Job No: 123081 - Building and Site Plans for 725 Lake Rd, Bowmanville, ON

Addendum No.: 2

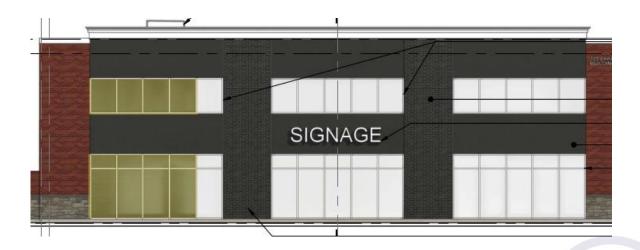
Architectural drawings note aluminum glazing as Kawneer 1650, however the Kawneer website shows only 1600. Some of our subcontractor supply carries Commdoor; is this an acceptable alternate for this scope of work; kindly advise thank you.

Answered above in question 1

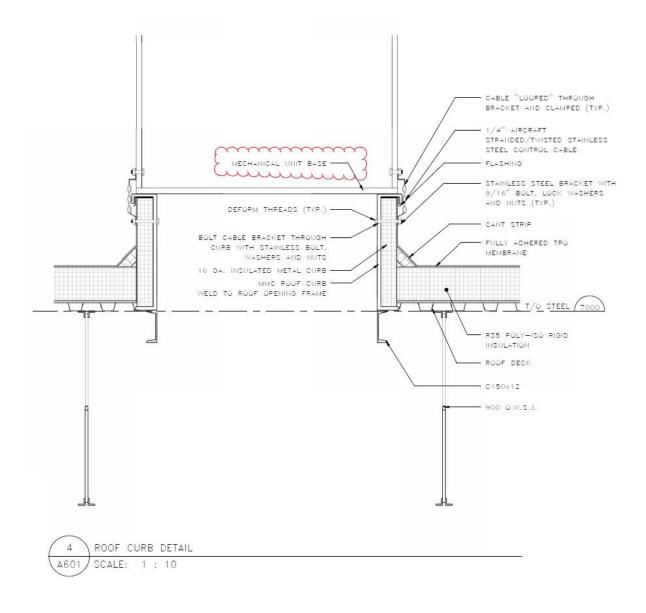
Landscape details #11 showing 1.8M HT. chain link fence w/ 50mm mesh; please indicate where on the plans is the fence detail.

Chain link fence is not proposed. The existing fence is proposed to remain.

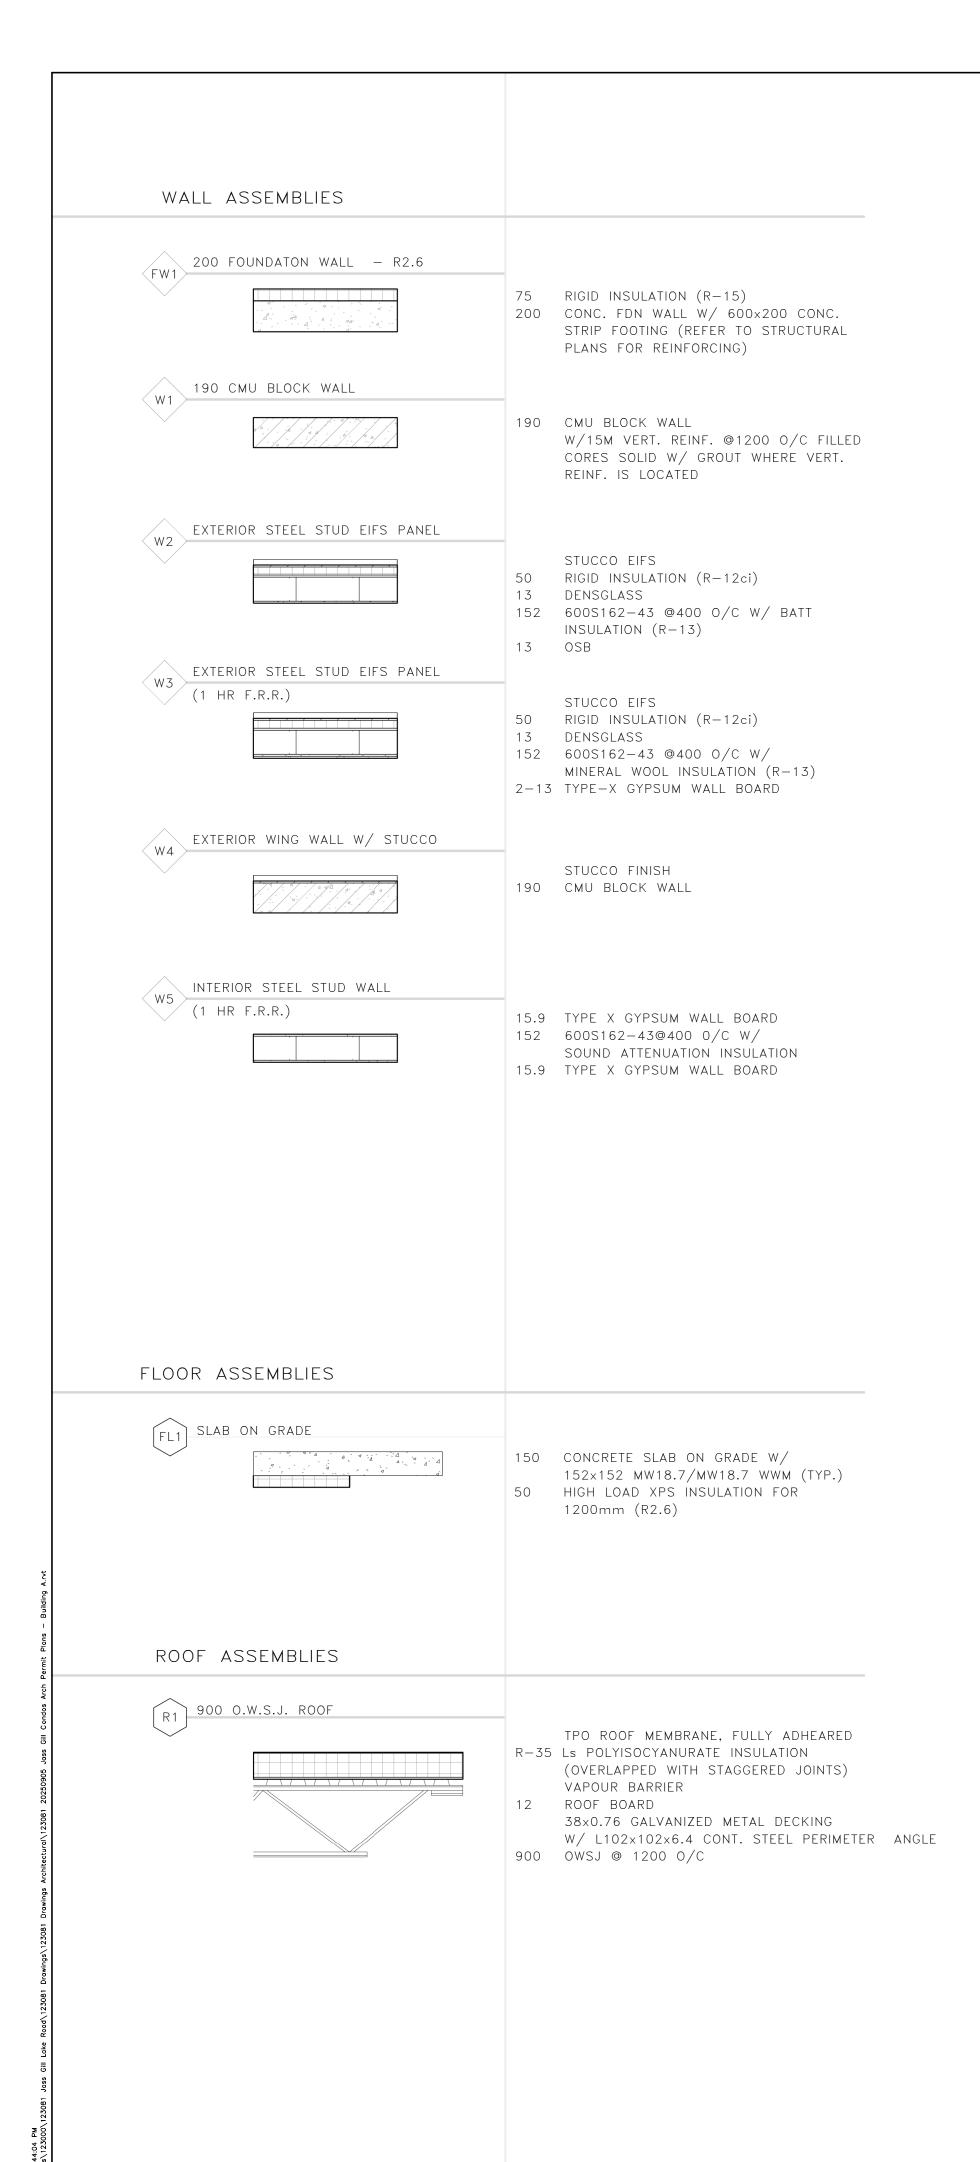
Is there any ventilation in the refuse room?

Yes, provide 125cfm ceiling exhaust fan ducted to wall cap termination. Intake air to be 12x12 Weatherproof intake louver complete with 3KW inline duct heater and airflow/temperature sensor.

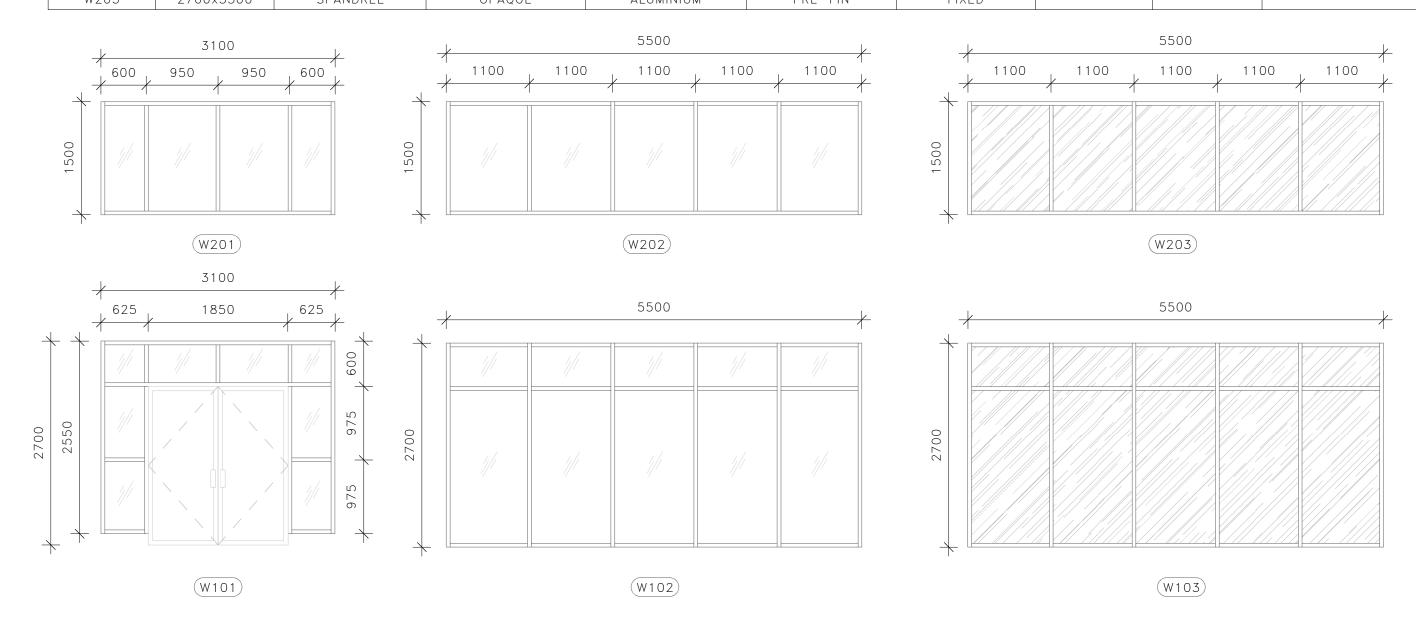
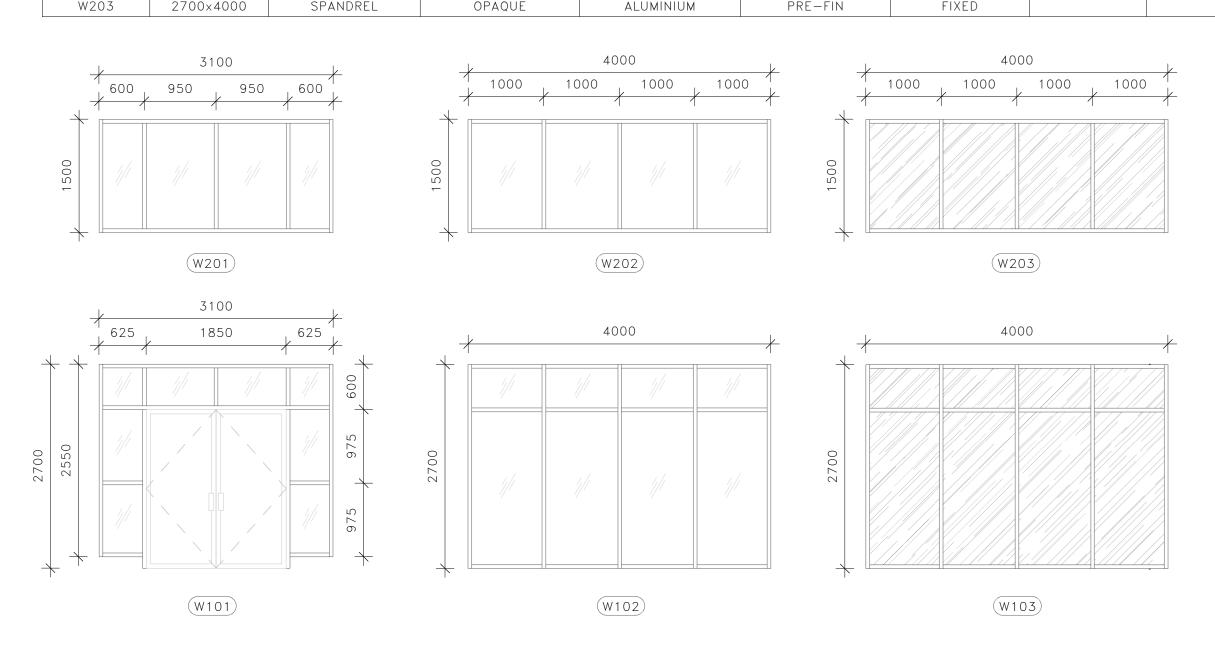
Can you also confirm if we are providing the "Spandrel Glass" locations as shown on the colored Elevations? Or as noted in the Window Schedule? Only one (1) 103 is affected as shown on elevations. This would be the similar case for bldg. B

Included in this addendum is a revised window schedule and floor plan that includes these high bay window and spandrel panels.
